ATTACHMENT: RESPONSES TO COMMENTS ON THE DRAFT EIR

FINAL ENVIRONMENTAL IMPACT REPORT FOR THE GWIN ESTATES SUBDIVISION

CITY FILE NO: ER 87-63
CITY REF. NO: PUD 89-270
SCH NO: 89030704

December 1989

Figure 2
 Illustrative Site Plan Under
 R-30 Zoning

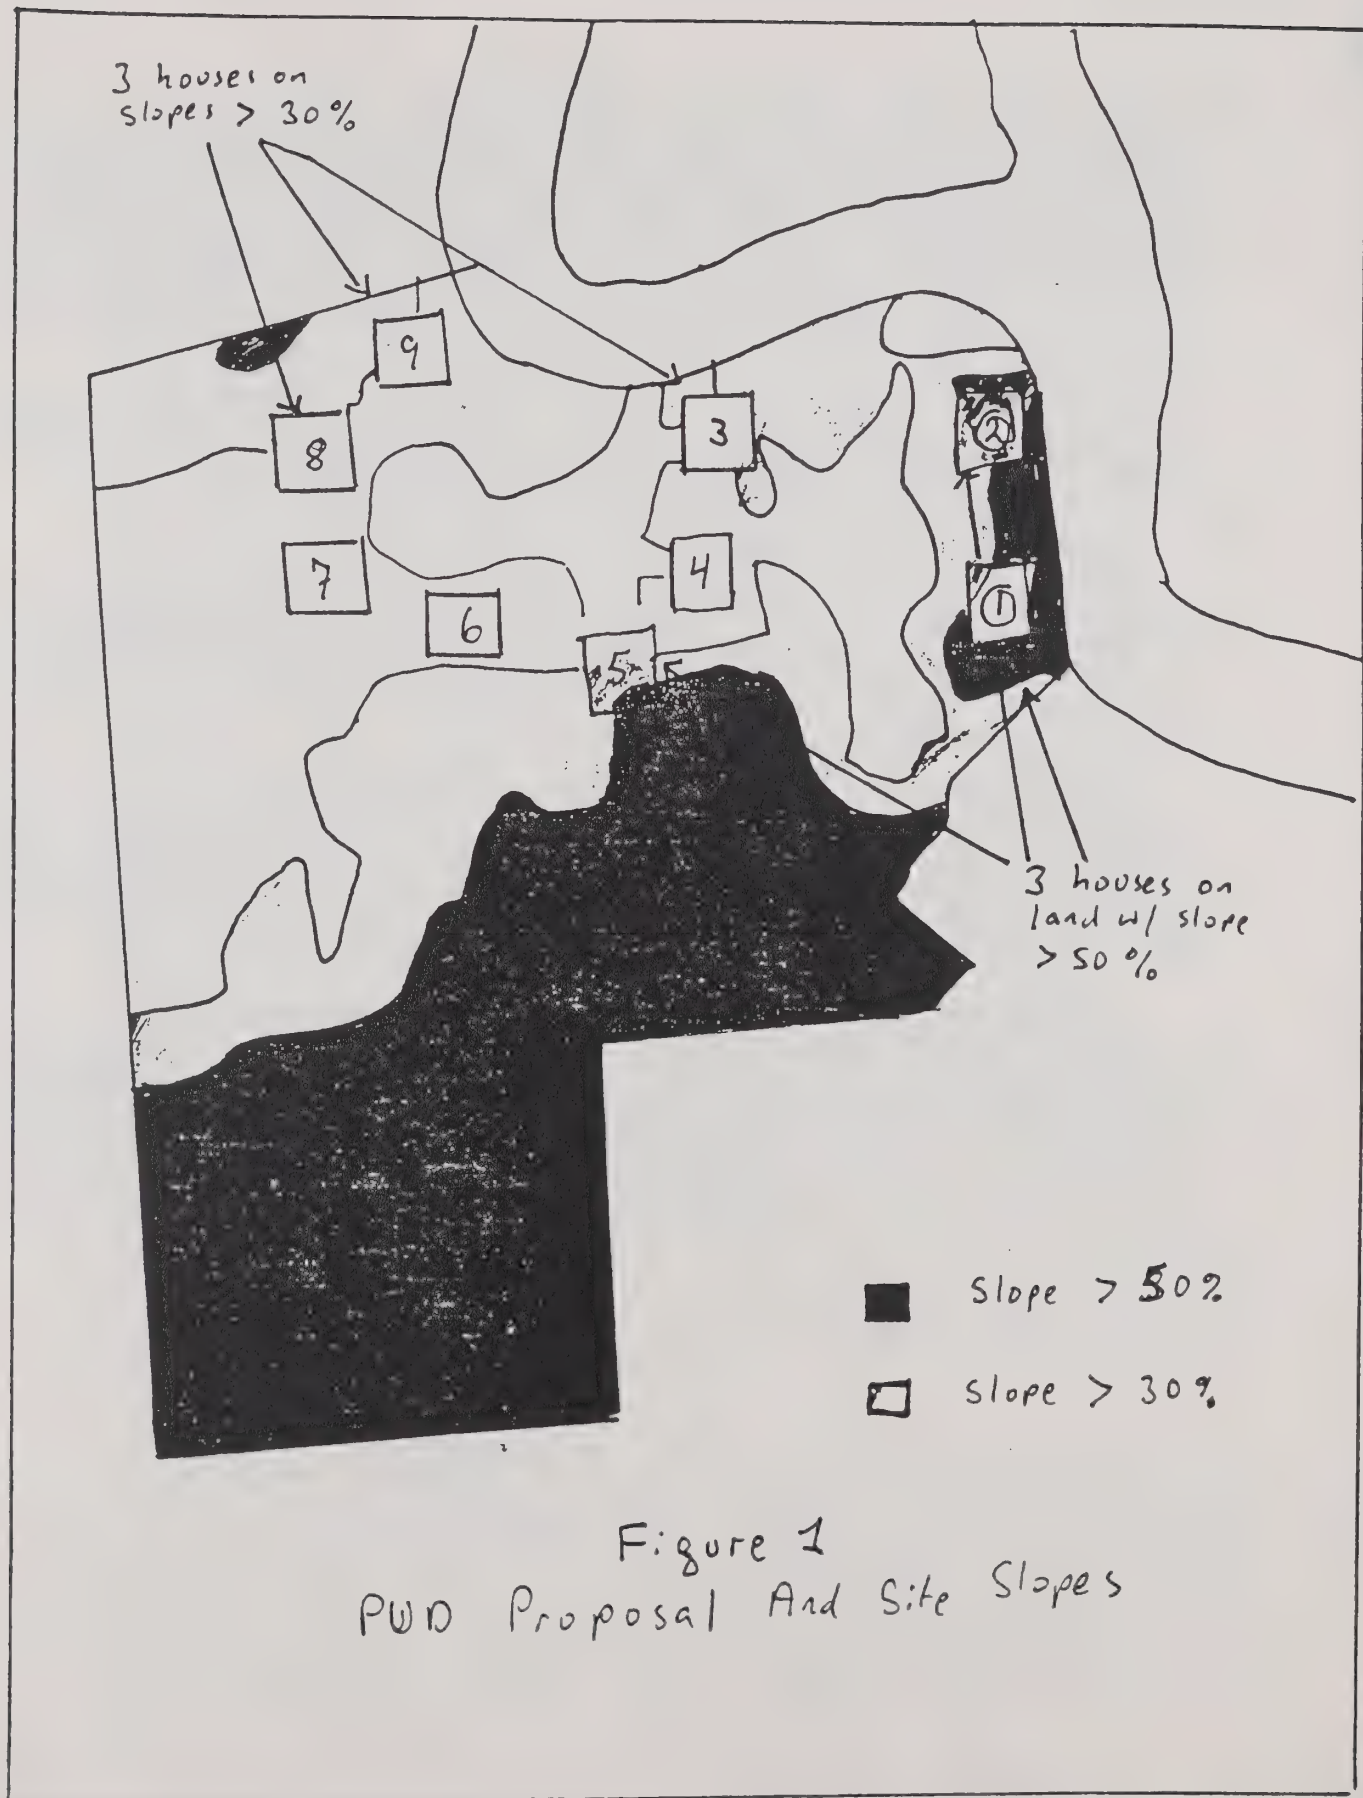
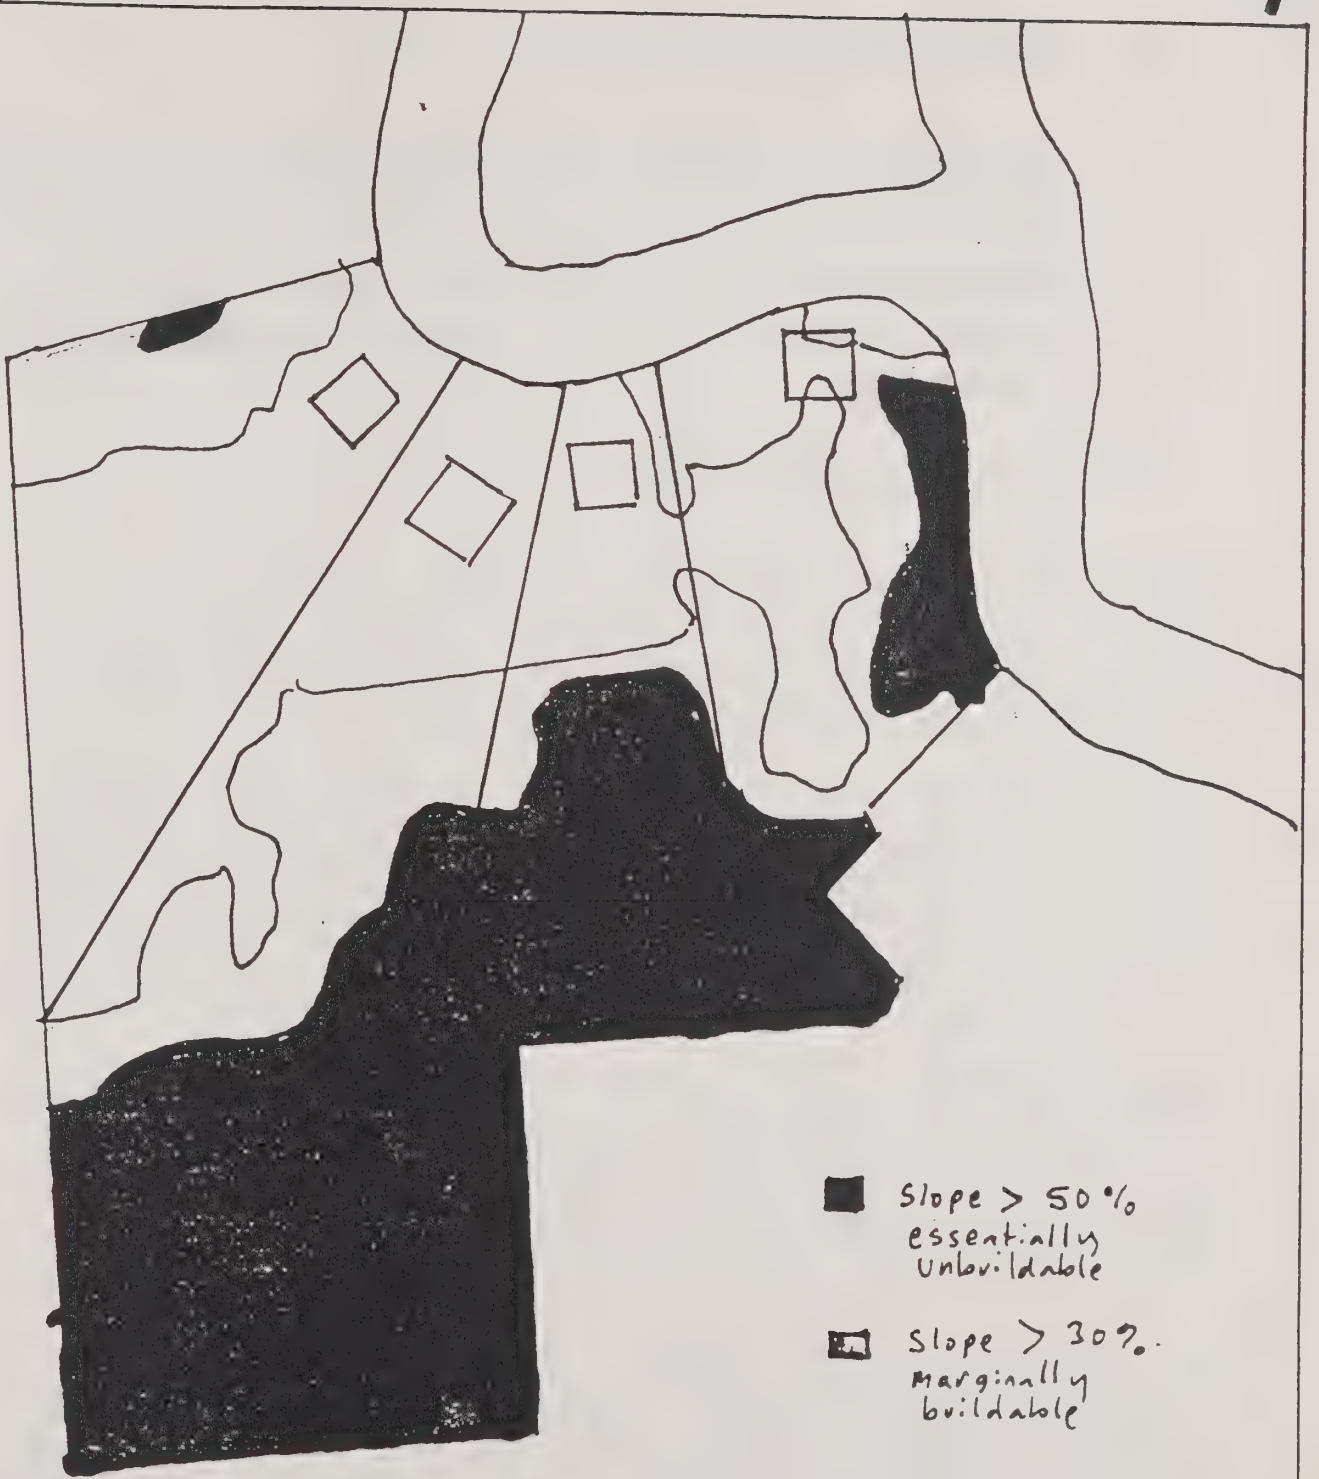
The site sold for approximately \$ 500,000 in 1988. This low land cost reflects the fact that two fifths of the site is essentially unbuildable because of slopes in excess of 50% and more than another fifth is marginally developable because of slopes in excess of 30% and other physical constraints (EIR figure 5 and p 115). It appears that four houses with access from Gwin Road could be built on the site under existing R-30 zoning (See Figure 2 attached to Richard LeGates' letter).

Figure 25

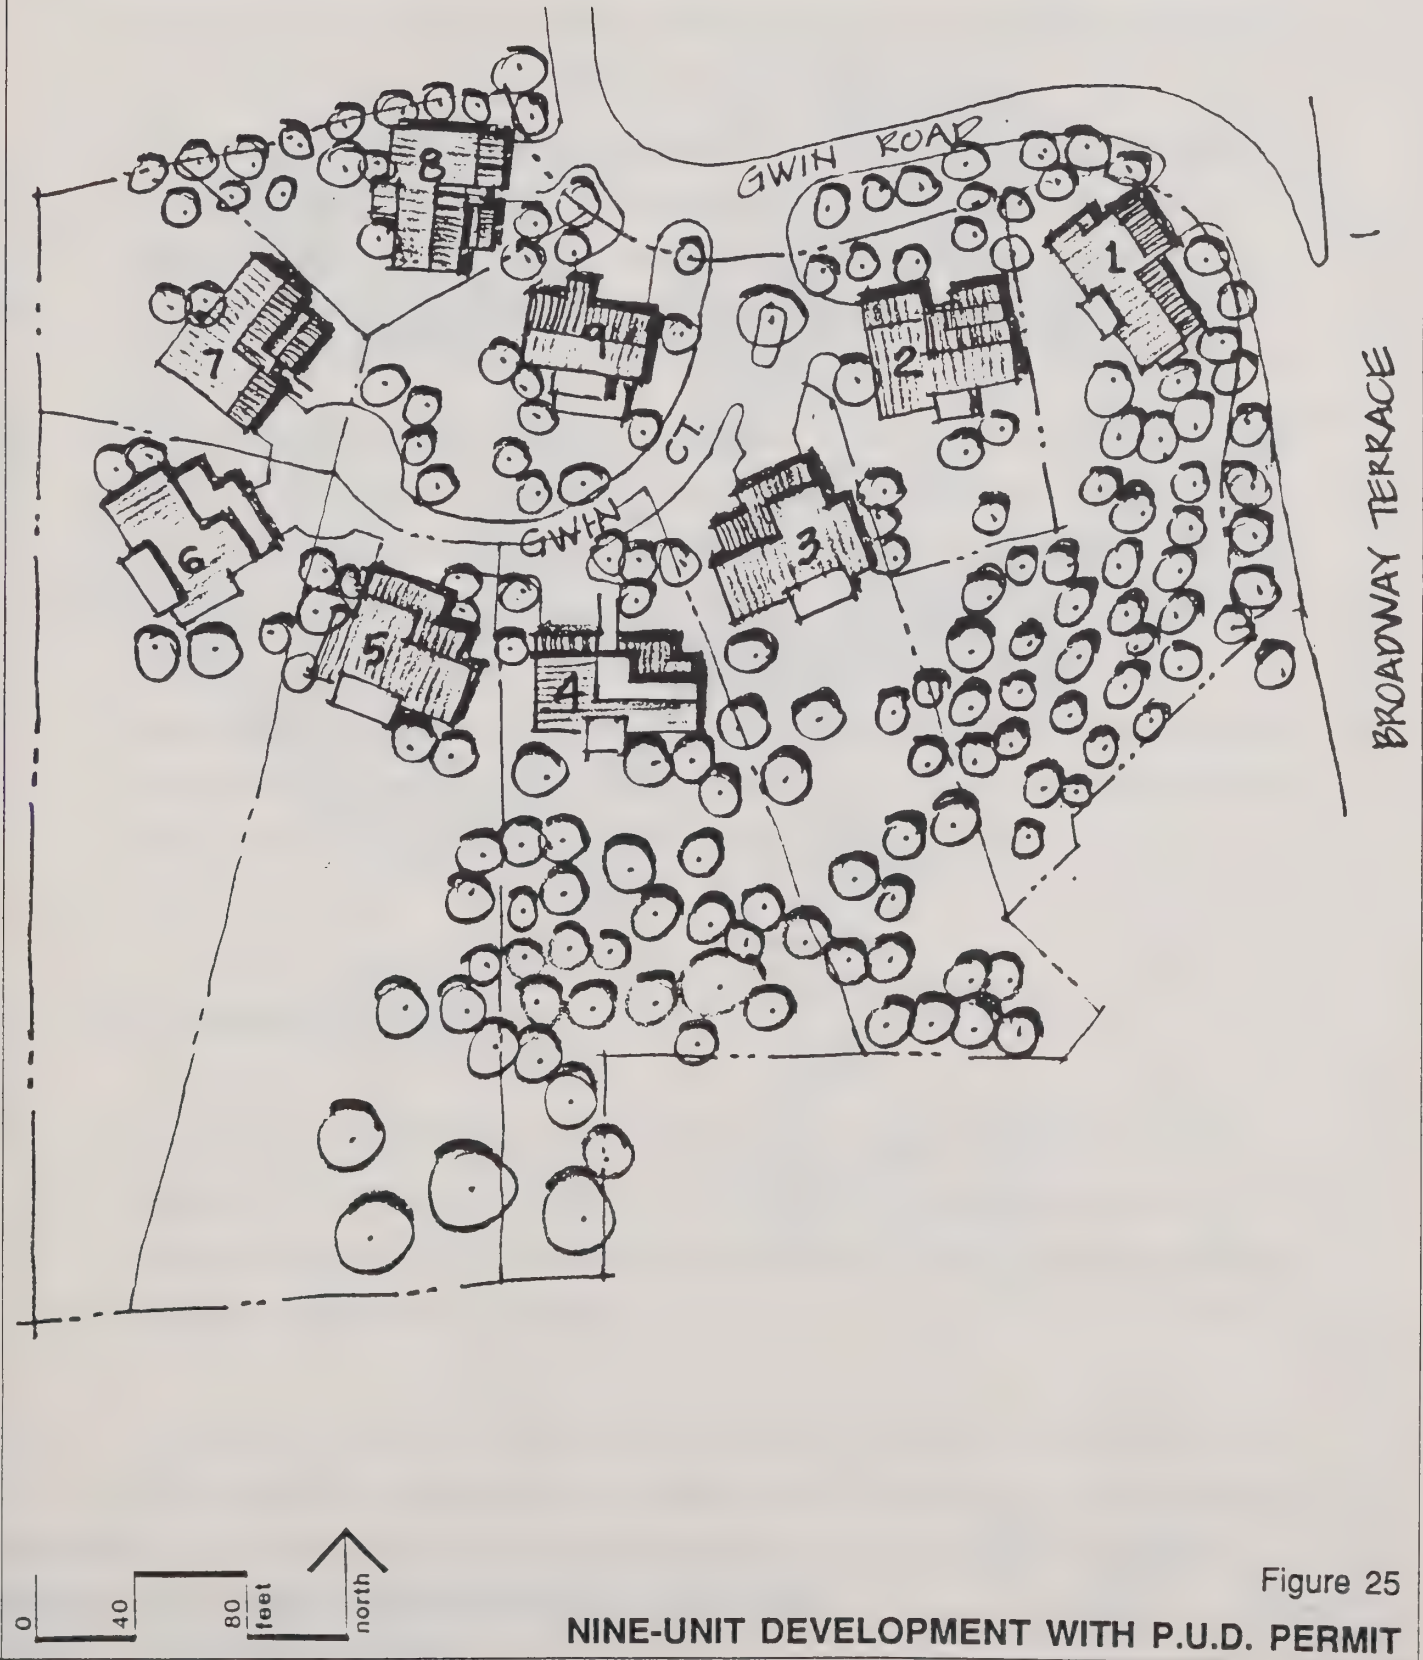
19. II. Summary of Findings, Page 28, Mitigation, line 18-28. Figures are mislabeled. Should be 26, 25, and 24, respectively. The seven unit plan shown on Figure 26, is absolutely not feasible. It is not possible to bring the cul-de-sac to the location shown through such a short path. Retaining walls would be well over 20 feet high, and the houses inaccessible.

- 3.19 The EIR figure references have been revised in response to this comment (see errata in section IV of this attachment). The comment regarding the engineering difficulties presented by the roadway alignment shown on Figure 26 is acknowledged. A revised schematic for this alternative has been included in the DEIR errata (see the revised Alternatives chapter in section IV herein).
- 3.20 Comment acknowledged. The ravine fill, tree removal, and driveway location issues have been addressed in response to Comments 3.5, 3.3, and 3.1, respectively.

Figure 27

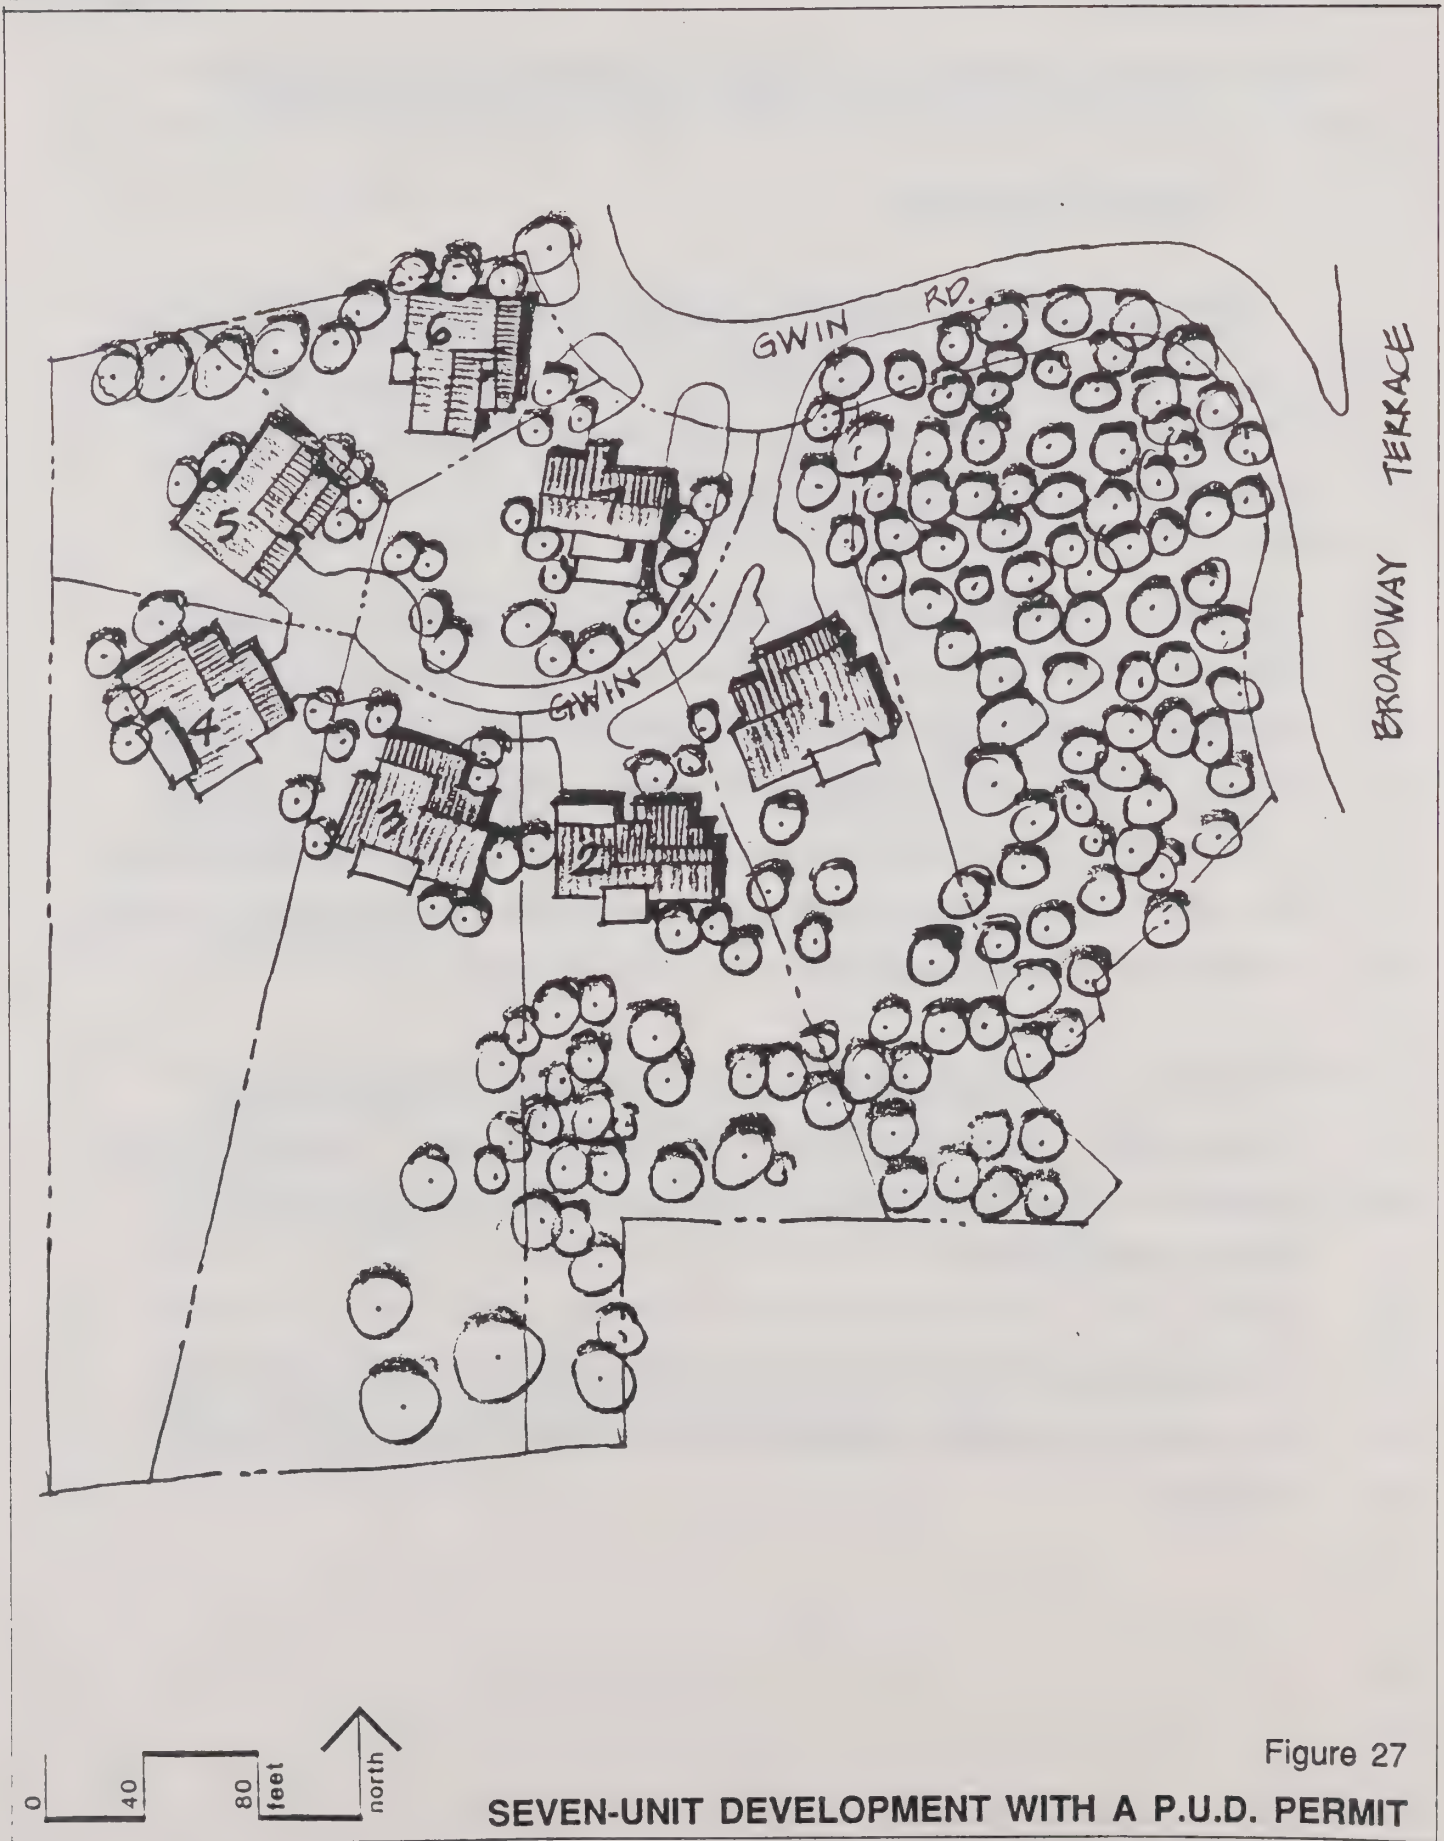
The seven unit plan shown on page 209 minimizes our concerns about fire since it substantially redesigns Gwin Court. We would urge the Planning Commission to withhold its approval of the ten unit plan and approve a plan that includes not more than seven units.

10 r As shown on Figure 27, the principal features of the mitigated site plan would be a
11 r further reduction in the number of units from ten down to seven units, and the
12 r movement of the residential areas back from the northern site boundary and from
13 Broadway Terrace and the Broadway Terrace/Gwin Road intersection. Under this
14 r revised scenario, the homesites would be located on the most suitable portions of the
15 r site: most of the seven units would be built on slopes of 30 percent or less. No units
16 r would be built on slopes equal to or greater than 50 percent.
